SUBJECT: Facility Decommissioning Evaluations (FDEs): Building 710-16D, Storage Building (G-FDE-D-00046, Revision 1, September 29, 2020), Building 484-5D, D-Area Powerhouse Storage Building (G-FDE-D-00047, Revision 1, September 29, 2020), Building 483-3D, Electrical Control Building (G-FDE-D-00049, Revision 1, September 29, 2020), Building 484-9D, D-Area Valve House (G-FDE-D-00055, Revision 1, September 29, 2020), and Savannah River Site's Responses to the Regulatory Comments on the Revision 0 FDEs for Buildings 480-3D, 704-7D, 710-16D, 484-5D, 483-3D, 485-D and 482-2D, 484-9D, and 717-3D, Simple Model

**Final SRS Responses to EPA Comments on the
FACILITY DECOMMISSIONING EVALUATIONS FOR:
Building 480-3D, Maintenance Field Office and Shop, Rev. 0, Dated April 28, 2020;
Building 704-7D, D-Area Maintenance Building, Rev 0, Dated April 27, 2020;
Building 483-3D, Electrical Control Building Rev 0, Dated April 28, 2020;
Buildings 485-D and 482-2D, D-Area Cooling Tower and Switchgear Building, Rev 0,
Dated May 11, 2020
Building 710-16D, Storage Building, Rev 0, Dated April 27, 2020
Building 484-5D, D-Area Powerhouse Storage Building, Rev 0, Dated April 27, 2020
Building 484-9D, D-Area Va

Figure 6B: 710-16D Opposite Side Of Wall From Storage 8 Spill Looking Northeast

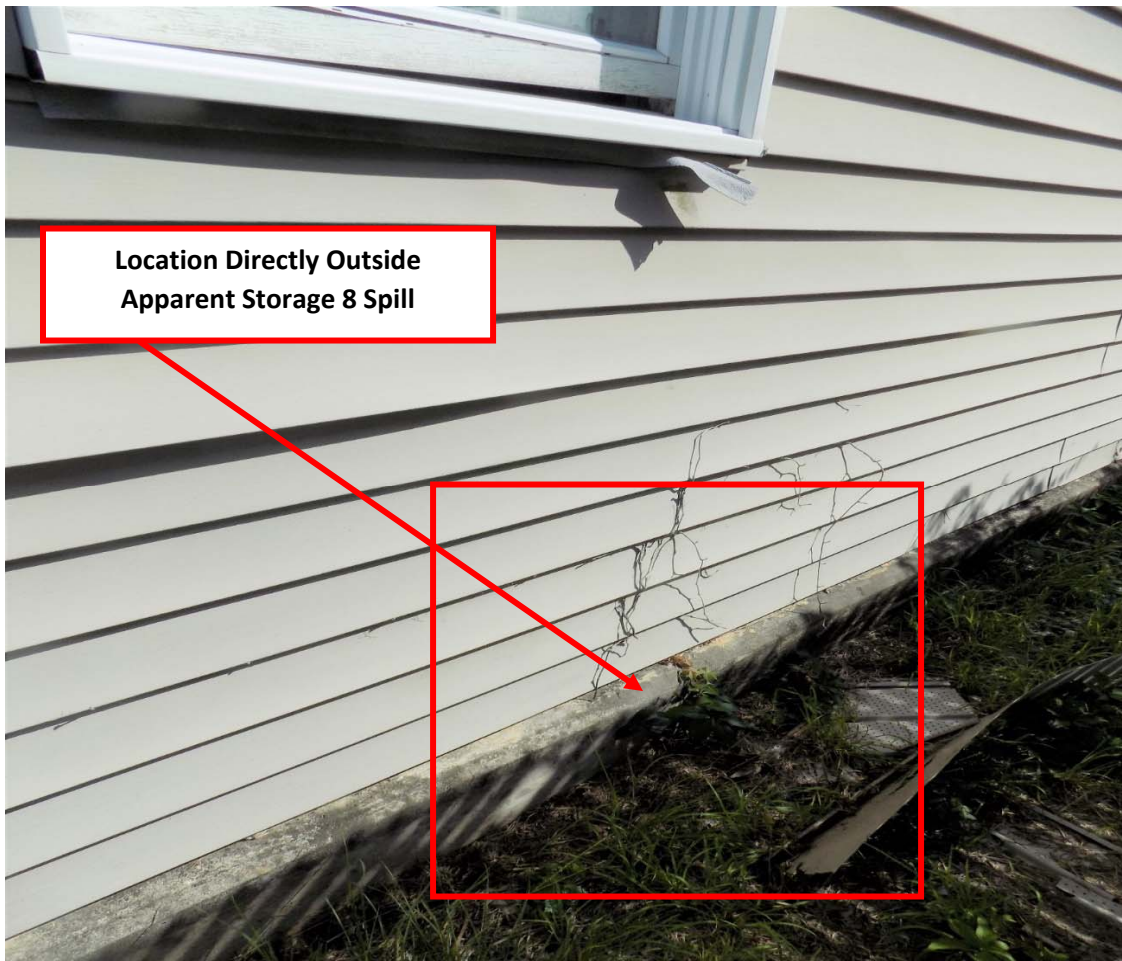
- a. Figure 2: The picture indicates that the spill impacted the area of intersection of wall with concrete. Has the exterior section of concrete/dirt area on the outside of this intersection been inspected/evaluated? Please include a photograph of this area.

Exterior section of concrete/dirt area on the outside was inspected. Visual inspection of the concrete, exterior to the building wall, and soil in close proximity shows no evidence that the apparent spill in Storage 8 migrated outside the facility. Reference Figures 6A through 6C showing the area directly outside the wall from the apparent spill in Storage 8. Note there is no indication of any staining of the concrete or soil that would indicate the apparent spill ever migrated outside the building wall. No change to the document is proposed.

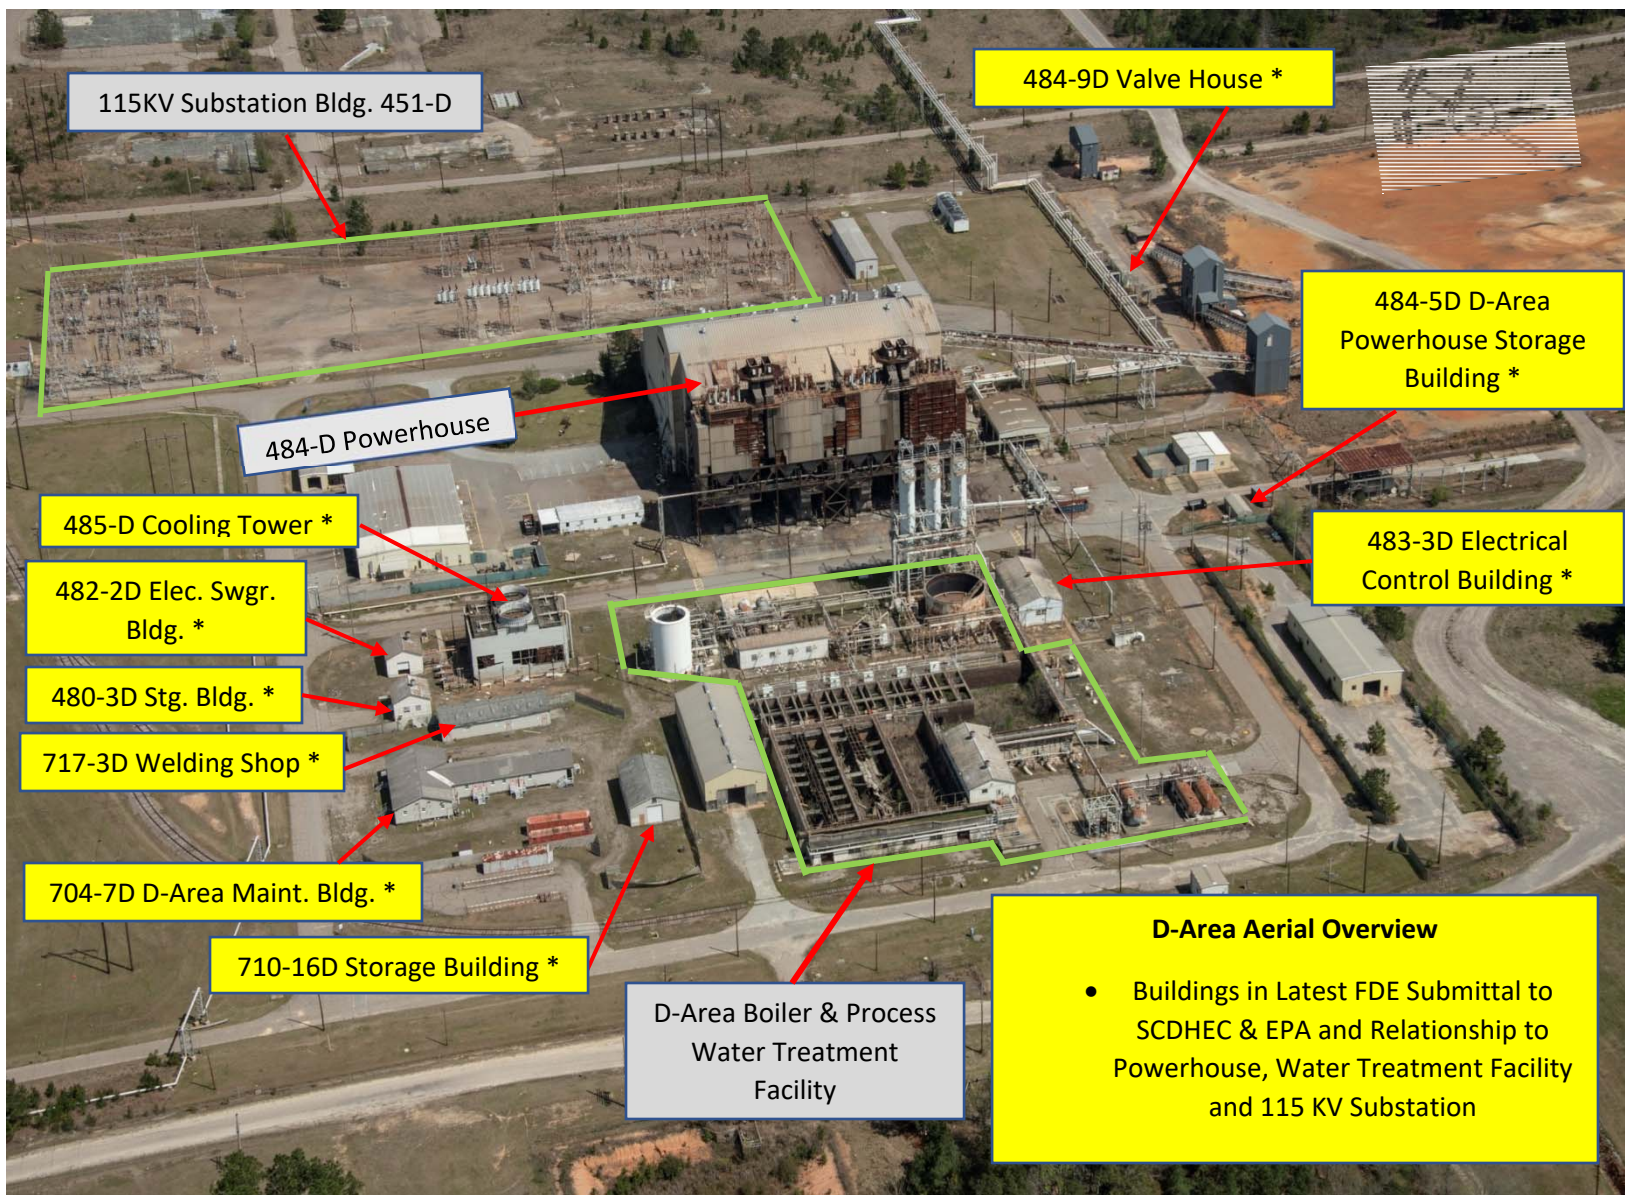
- a) For the purposes of clarity, please provide further explanation for isolation of all fire water (inclusive of the fire hydrant), steam, instrument air and electrical versus air-gapped. It is unclear if the above services are no longer usable and in a safe state prior to and following demolition.

Response: Clarification

Prior to demolition, each facility must have been rendered and verified to be “Cold & Dark” as is a typical practice based on our D&D procedures and protocols. No change to the document is proposed.

Attachment 1

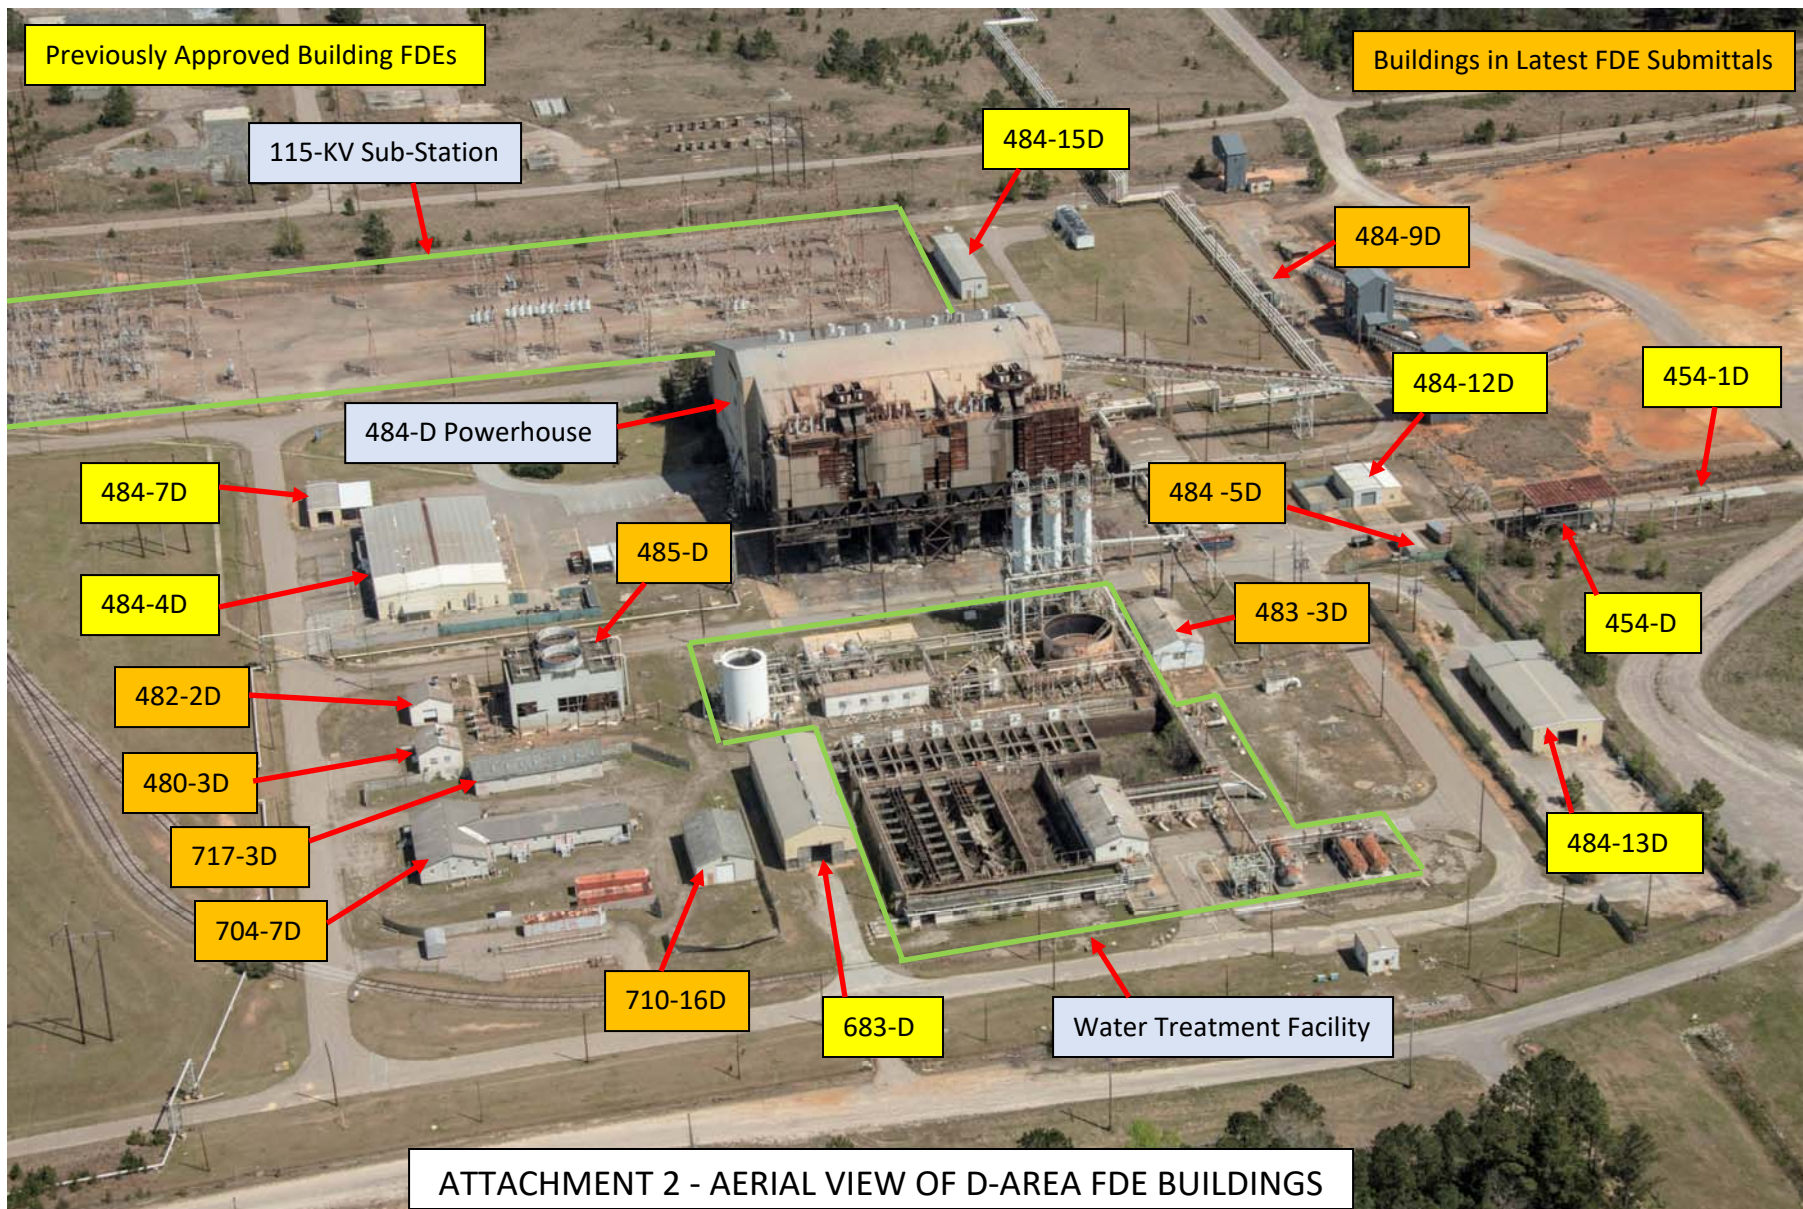
- 2) Please provide one figure that depicts the relationship between the 8 buildings and their ancillary structures. This figure should also include all previously approved FDEs buildings and ancillary structures.

See the attached aerial view of D-Area (Attachment 1) which shows the 9 total buildings within the scope of these eight subject FDEs (one FDE included 2 buildings) and their relationship to the 484-D Powerhouse, the D-Area Boiler and Process Water Treatment Facility, and the 115 KV power company substation. Attachment 1 shows each building's number and name. Ancillary structures are too small to show on the aerial photo. See each individual FDE for photo(s) of ancillary structures.
